Appendix F: Design Midlands Response

Leaford Solar Farm Application - Landscape Comments

Design:Midlands are working with Stafford Borough Council in providing expert landscape input on Leaford Solar Farm application (reference 24/38719/FUL). This has involved Fiona Heron (Landscape architect) undertaking a thorough site visit with Dryden McNair Lewis and Vanessa Blake from Stafford Borough Council officers including a briefing on the site history and local context and undertaking an assessment of the planning application, specifically the Landscape and Visual Impact Assessment (LVIA).

2.1 Strategic Approach to location of panels & Red Line/Development Boundary

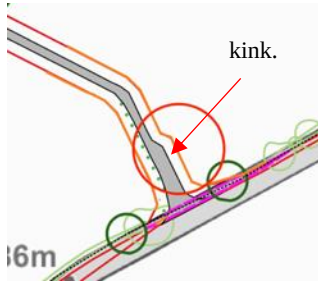
- Hedgerows and existing field patterns generally define locations of panels though there are a number of exceptions primarily related to topography or screening.
- The red line boundary does not always follow the hedgerow lines or field pattern and splits Field 5. The red line boundary at fields 15/16, 17 appears to respond to the topography however mitigation indicated in the LEMP for 17 is outside the red line boundary. This presents potential legal problems.

Proposed hedge bend & narrowing

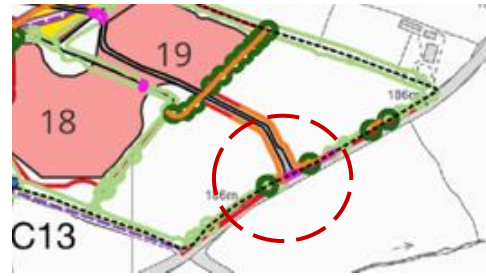
- Localised sections of hedgerow or planting will be removed for a 4m wide access track.
- Vehicular access is provided from Saverley Green Road with a resulting large visibility splay of 160m and 46m of hedgerow will need to be trimmed to 1.05m high.
- The access track between 18 and 19 bends to avoid tree loss on Saverley Green Road.
- The reduction of the width and how this point is treated however is unnatural, man-made and unsympathetic to the context.
- The double hedgerow at the entrance (view 2c below) is not characteristic of the area. This new planting/ hedgerow will be permanent so will need sensitive landscape treatment.
- The approach here will have a negative impact on the character and nature on of the road which is currently lined on both sides by verges and a well maintained hedgerow.
- The approach here needs further consideration.

LVIA View 2a currently from Saverley Green Road towards field 19

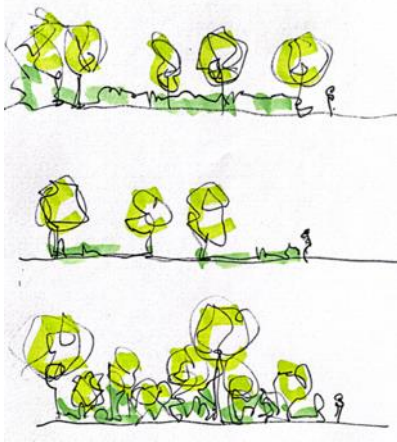
- The photographic montages below [View 2 from the LVIA] show that panels 18 and 19 are not likely to be visible from the road and there is additional planting on the border of 19.

Current hedgerows, stream, path and solitary tree with new hedgerow from Little Leacroft farm

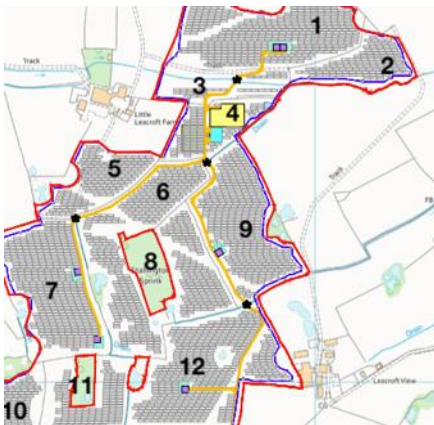
- There is a logic to infilling/adding trees and extending existing east-west hedgerow between 3 and 4 towards Little Leacroft Farm.

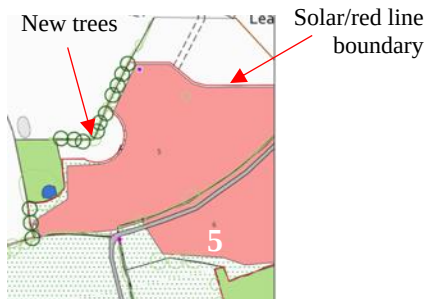
- There are areas in the ecology management plans where it is indicated in an orange line that “Proposed native Hedge species are maintained to greater than 3.5m”. These are often outside the boundary and in some instances it is not clear that these hedgerows exist for example on the southern boundary of field 15

View on C3 towards horizon following PRoW with 2 distinct 'navigational' trees and style

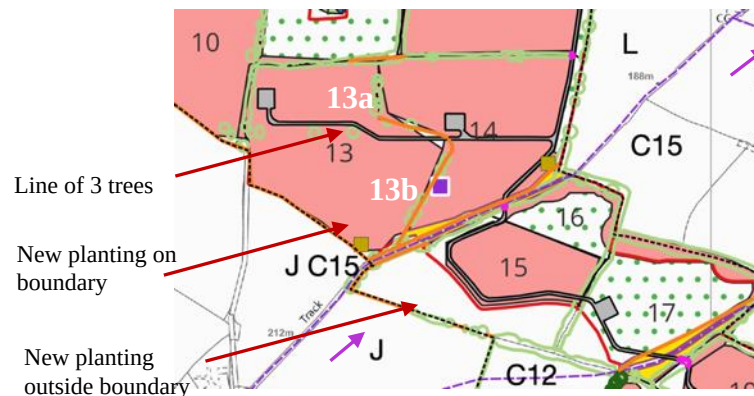
- This is long-distance route through the churchyard, with a visible style leading to the more open countryside beyond. The land rises directly to face the horizon interrupted at points by hedgerow and trees. To the west are clear views of gently undulating open countryside with characteristic hedgerows (sometimes gappy) and groups of trees and to the east similar open ground with the rising hill obscuring any view of the site.
- No sign of the sight will be visible from this point until the top of the ridge is reached prior to the next style.

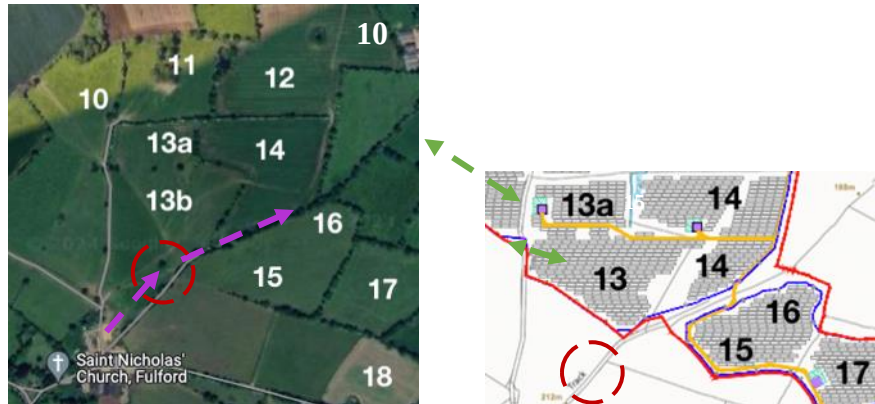
- There are a number of isolated trees outside the site to the south of the boundary of 13. There are also 3 existing mature trees on site which separate what is indicated as 13a

and 13b. Whether these were part of a remnant hedgerow and could contribute to screening could be considered and also the impact of planting in 13b and whether there should be panels here.
